Glenfield Borough
v.
Consolidated Rail Corporation, Allegheny County
and Pennsylvania Department of Transportation

IN REPLY REFER TO
Allegheny County
Glenfield Viaduct
Glenfield Borough
PUC. C. 80092154

Reference is made to Mr. Moyer's letter of September 22, 1986 transmitting detail construction plans for replacement of subject structure.

SHEET 1 OF 39

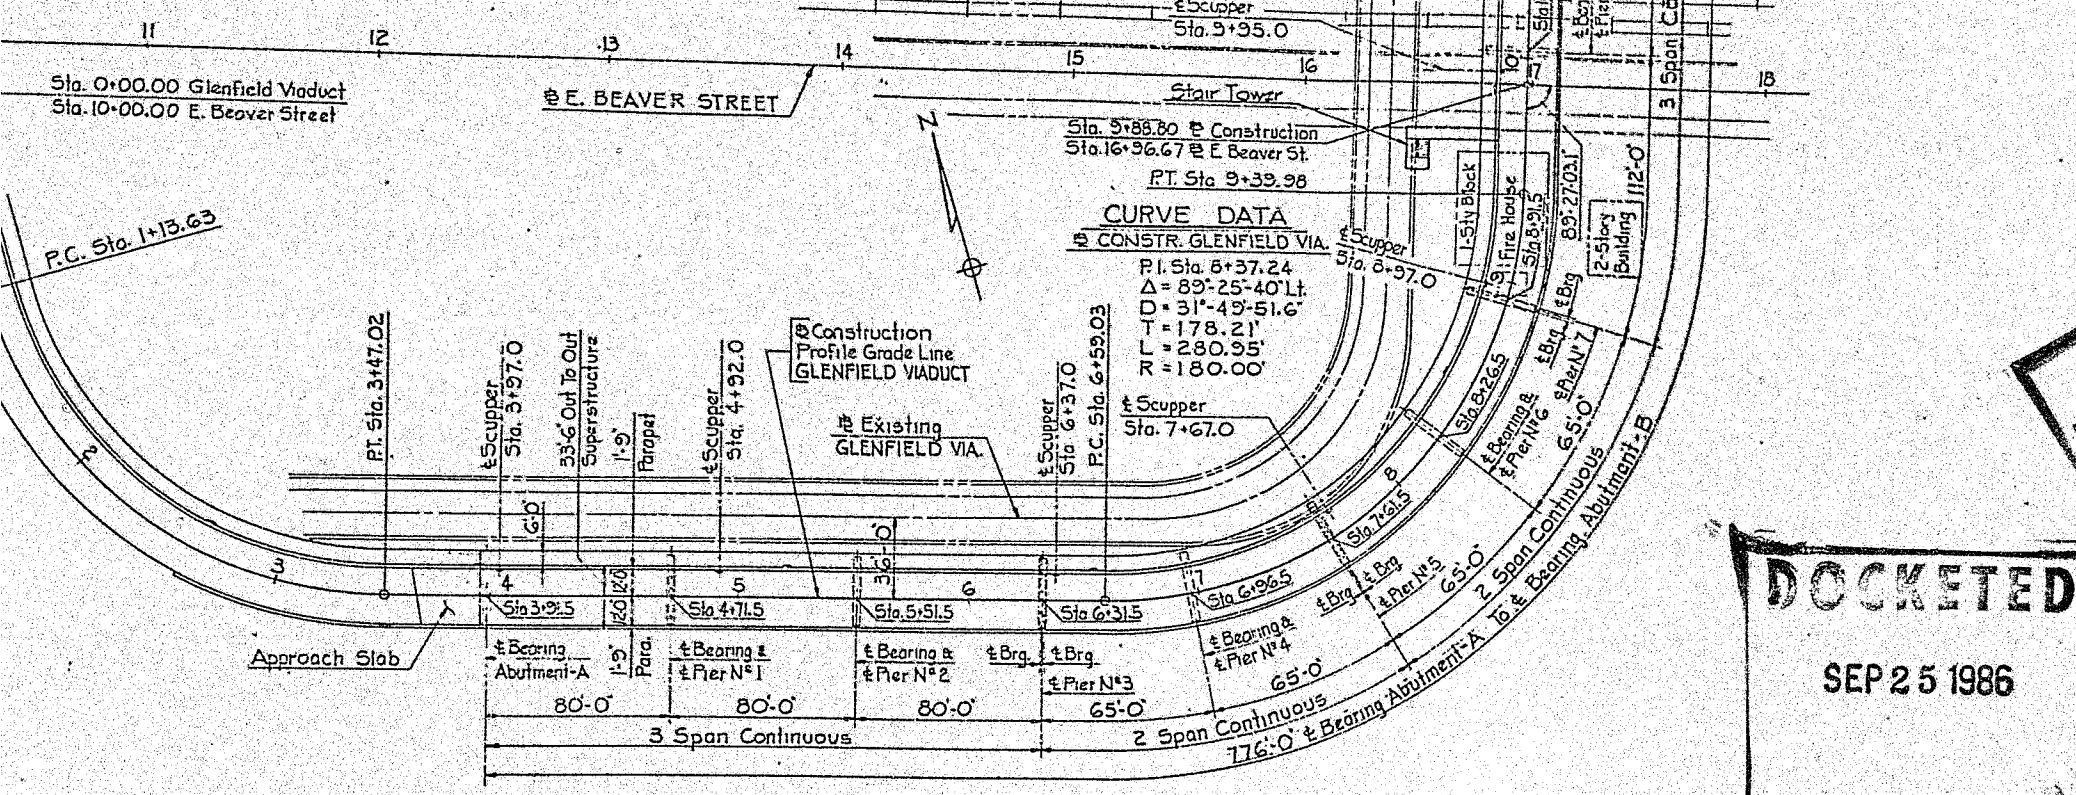
2. Disposition of the scupper discharge should be addressed (see sheet 1 of 39, sta. 10 + 75.0). We would prefer that no drainage from the bridge structure be discharged on Conrail property; however, if this is not feasible, the discharge must be conveyed by means of a pipe to existing drainage structures.

SHEET 2 OF 39
S-16201

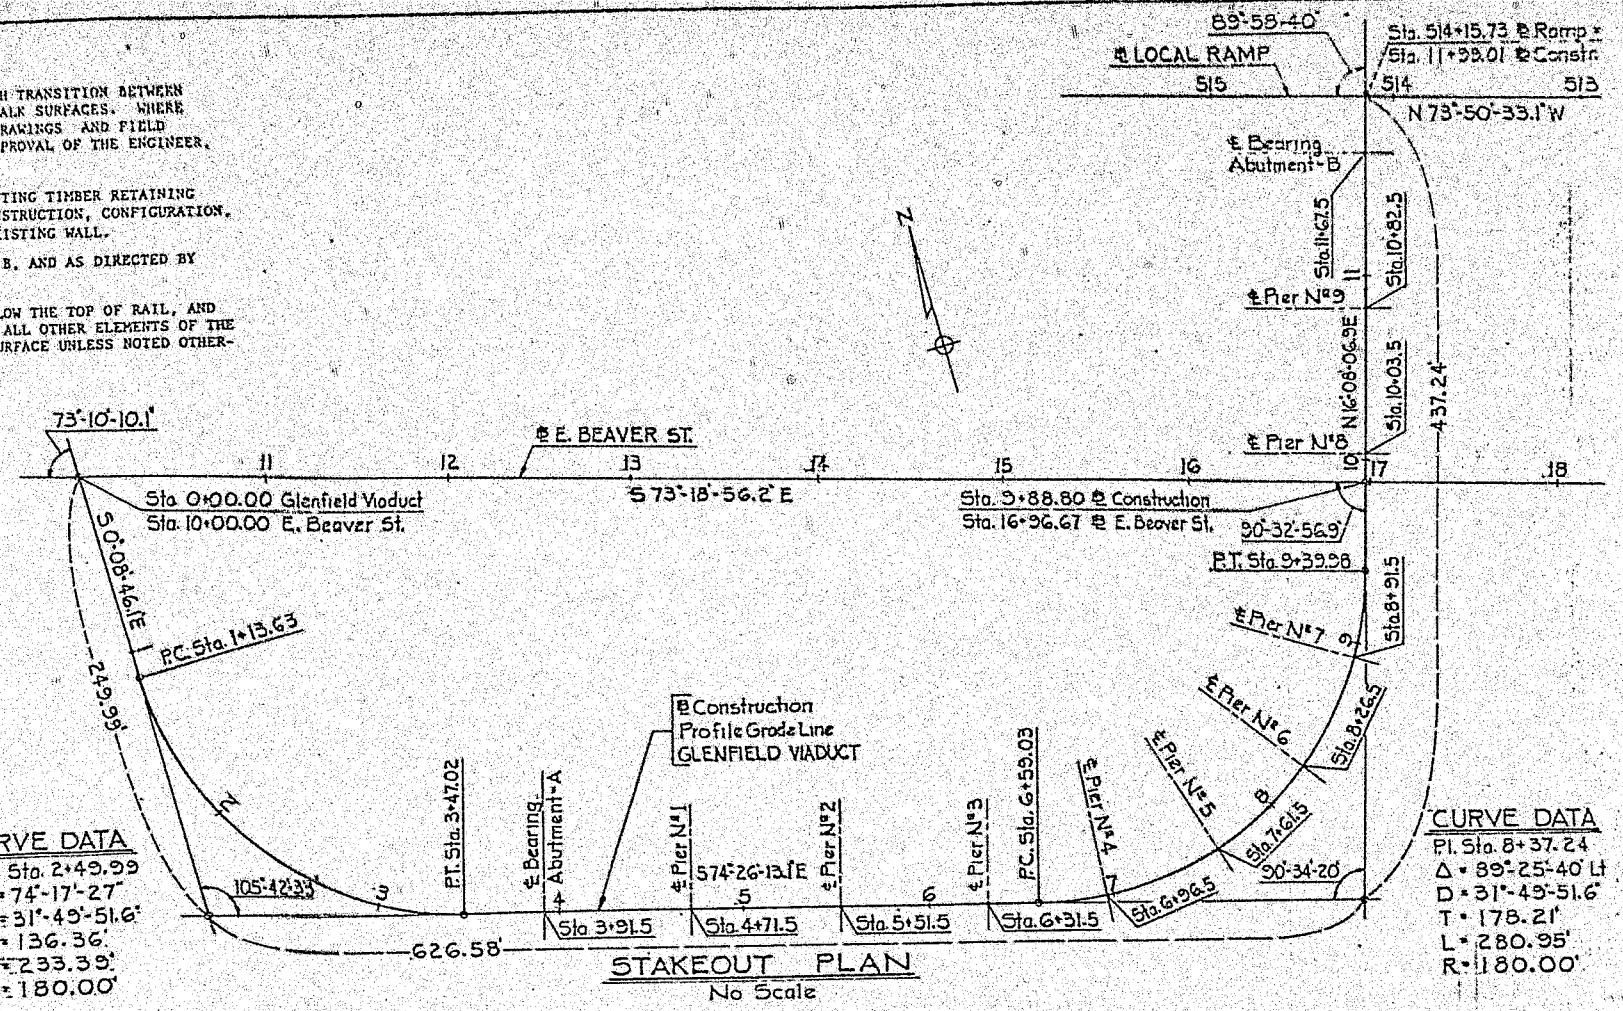
3. As presently designed, the temporary sheeting of Pier 8 will be only about 5' from centerline of track and approximately 15 feet deep. Details of sheeting and of supports and replacements for existing crib wall (see sheet 2 of 39) should be submitted for approval by this office before commencement of work.
